SERVICE BULLETIN

#0014 Revision 1

SUBJECT: Rivet replacement along fuselage main spar carry-through and on upper and lower inboard wing skins

MODELS AFFECTED: All Sling aircraft

Figure 1 - Paint cracking around rivets on Sling 2 wing

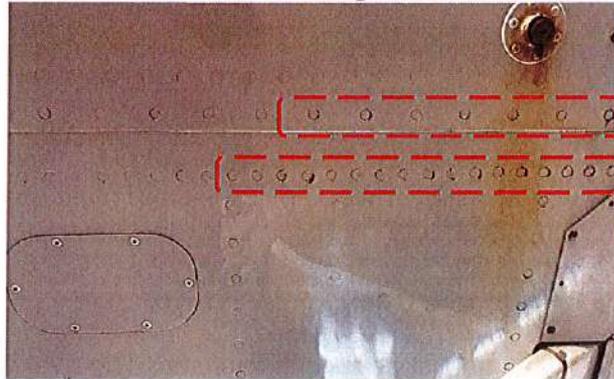
In some Sling aircraft, an indication of this condition is paint cracking around the rivets. The affected regions are usually located on the underside of the fuselage along the main spar carry-through and on upper and lower inboard wing skins. Figure 1 shows paint cracking on the inboard skins of a Sling 2 aircraft.

To minimise fretting, rivets in the affected areas should be replaced with Avinox stainless steel rivets (Part number BE61-00512).

Figure 2 – Region of rivet replacement on the underside of starboard (right) wing

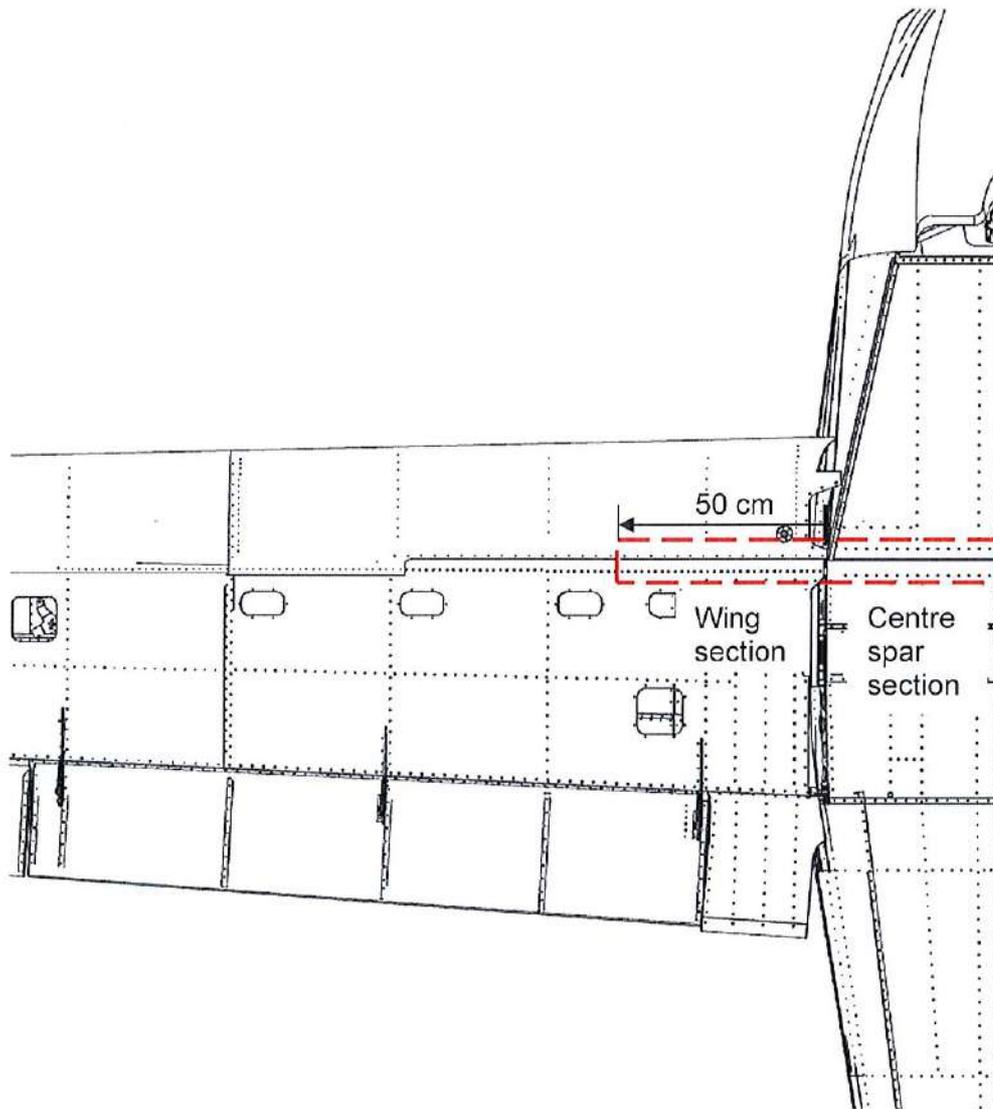
2. On the fuselage (of Sling TSi, Sling 2 and Sling 4 aircraft), this region is along the two rows of rivets that attach the underside centre fuselage skin to the centre spar (see Figure 2).

3. Figure 2 shows one half of the affected region on the underside of the starboard wing and fuselage and Figure 3 shows half the affected region on the upper starboard wing. The quantity of rivets recommended should cover these regions sufficiently.

The Figure 2 and 3 indicate the regions where rivets should be replaced on the aircraft. The rivets for the Sling TSi are replaced only on the centre spar carry-through under the fuselage.

5. Ensure that rivet removal is complete on the top of the wing before starting with the underside.
6. Using the powered drill with the 4 mm drill bit, drill the heads off rivets in the affected regions indicated in Figure 2 and 3 (specifically Figure 4 for Sling 2 and Figure 5 for Sling 4 wings). If rivets are filled, indent the centre of the rivet head with a centre punch and hammer before drilling.

Figure 4 - Number of rivets to replace on Sling 2 and Sling LSA wings

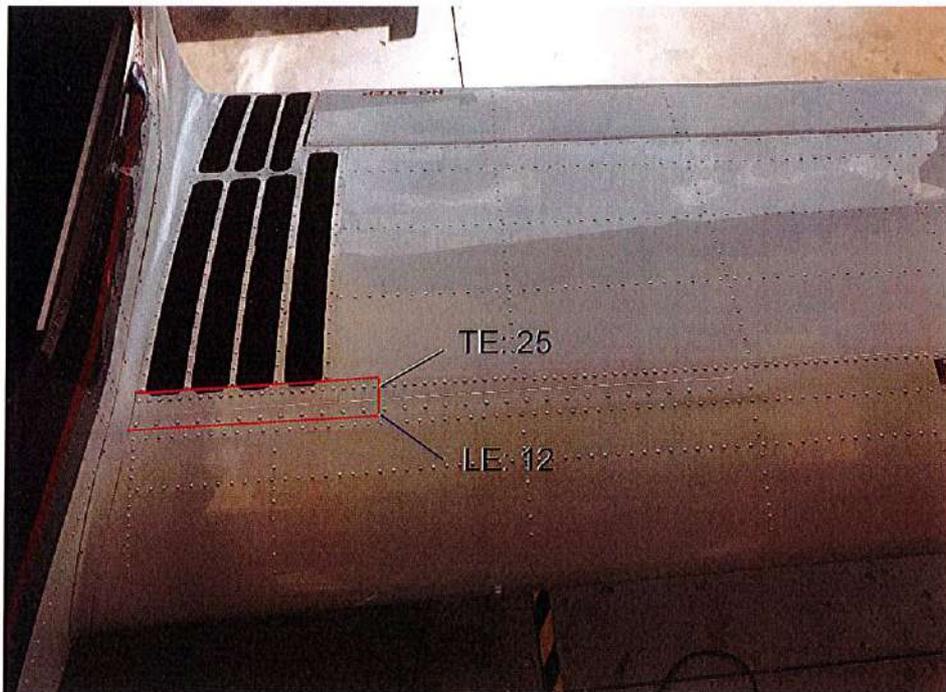
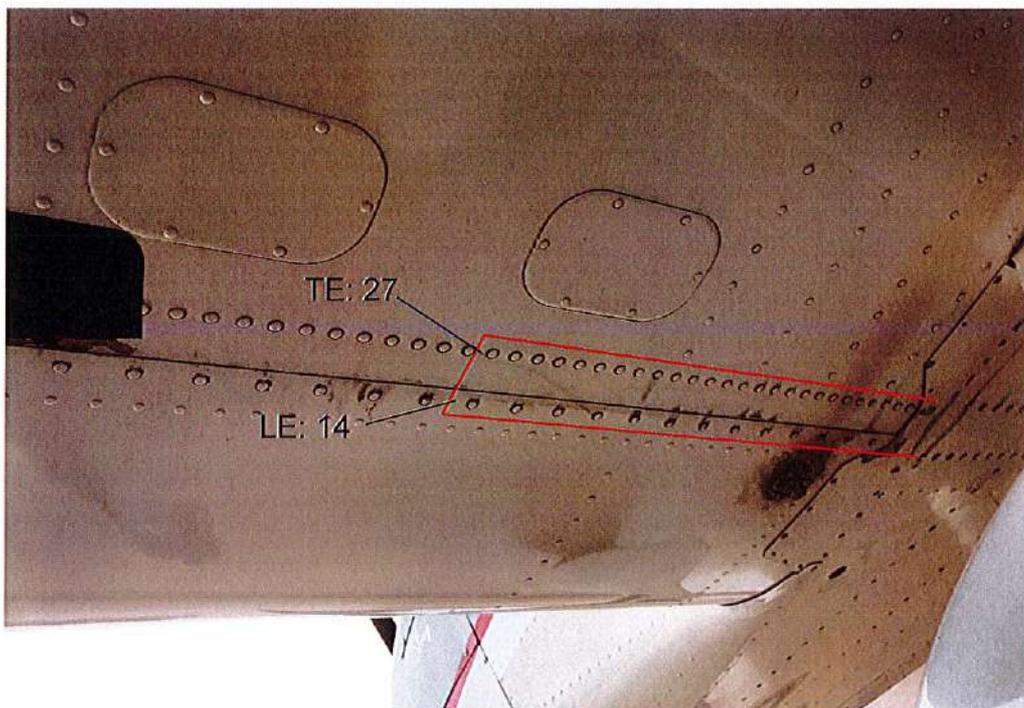
At approximately 50cm (spanwise distance) from the wing root, on the Sling 2 wings, the rivets to be replaced are 12 on the front section (leading edge) and 25 on rear section (trailing edge) of the upper wing spar. On the underside of the Sling 2 wing, the rivets to be replaced are 14 on the leading edge and 27 on the trailing edge as shown in Figure 4.

Hence, the total number of rivets, for both wings = $[(12 + 25) + (14 + 27)] \times 2 \rightarrow 156$ (wings only).

The number of rivets along the centre spar carry-through under the fuselage $\rightarrow 62$ (centre spar only).

In total: $(156 + 62) \rightarrow 218$ rivets (Sling 2)

Figure 5 - Number of rivets to replace on Sling 4 wings

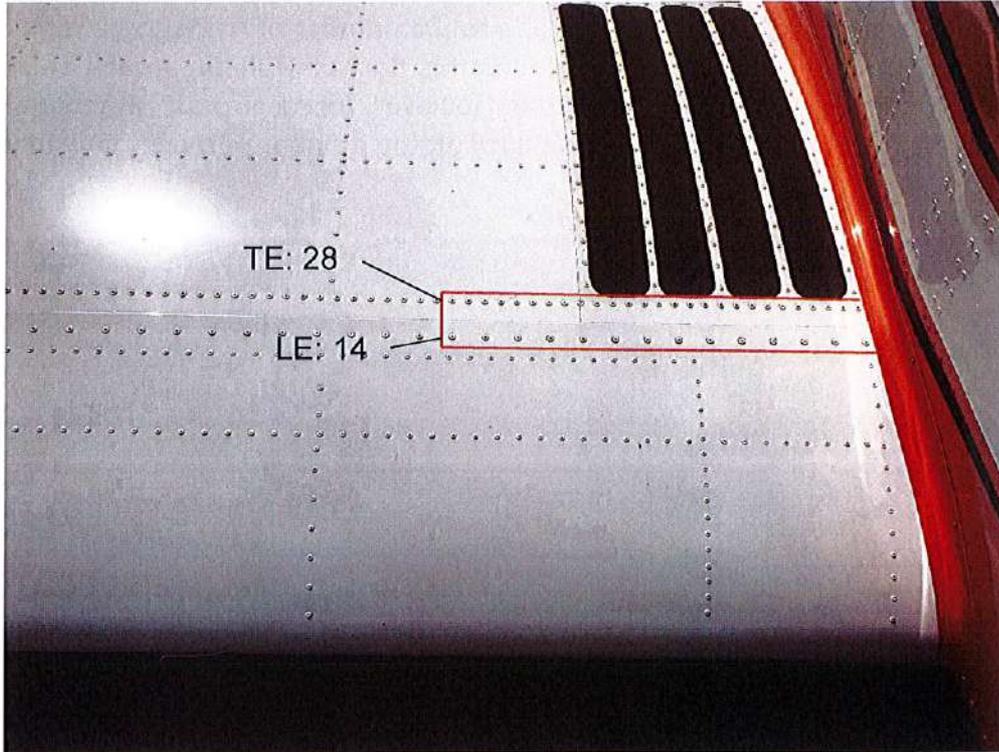
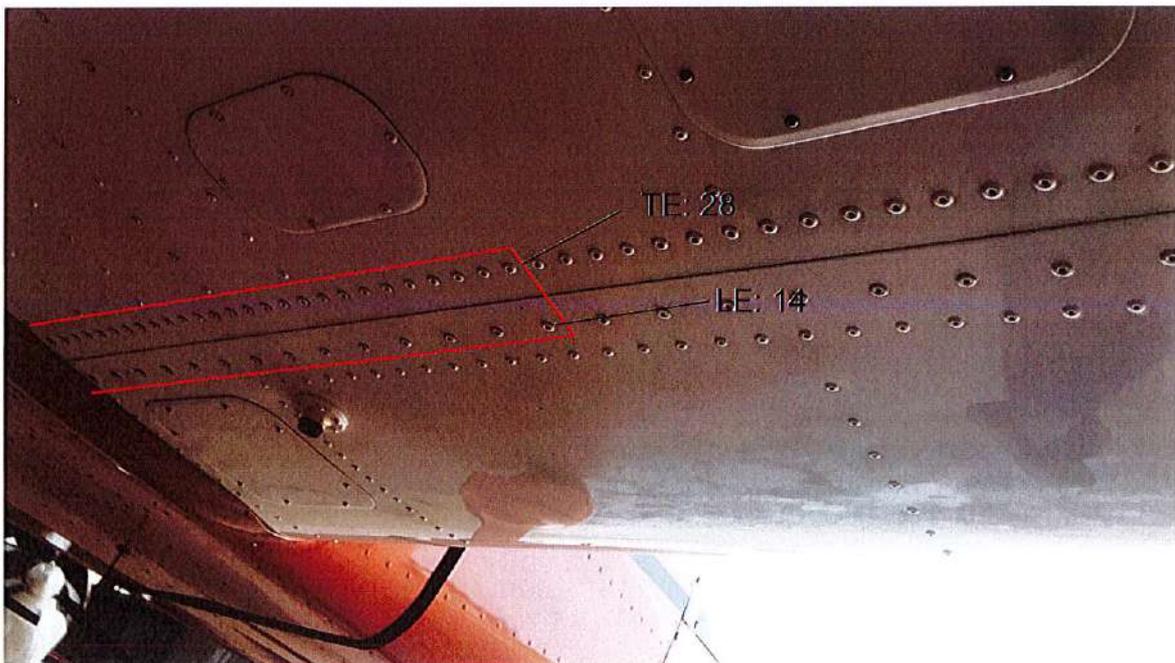
As illustrated below, on the Sling 4 wings, the rivets to be replaced are 14 on the front section (leading edge) and 28 on rear section (trailing edge) of the upper wing spar. On the underside of the Sling 4 wing, the rivets to be replaced are again 14 on the leading edge and 28 on the trailing edge. Hence, the total number of rivets, for both wings = $[(14 + 28) + (14 + 28)] \times 2 \rightarrow 168$ (wings only). The number of rivets along the centre spar carry-through under the fuselage $\rightarrow 62$ (centre spar only). In total: $(168 + 62) \rightarrow 230$ rivets (Sling 4)
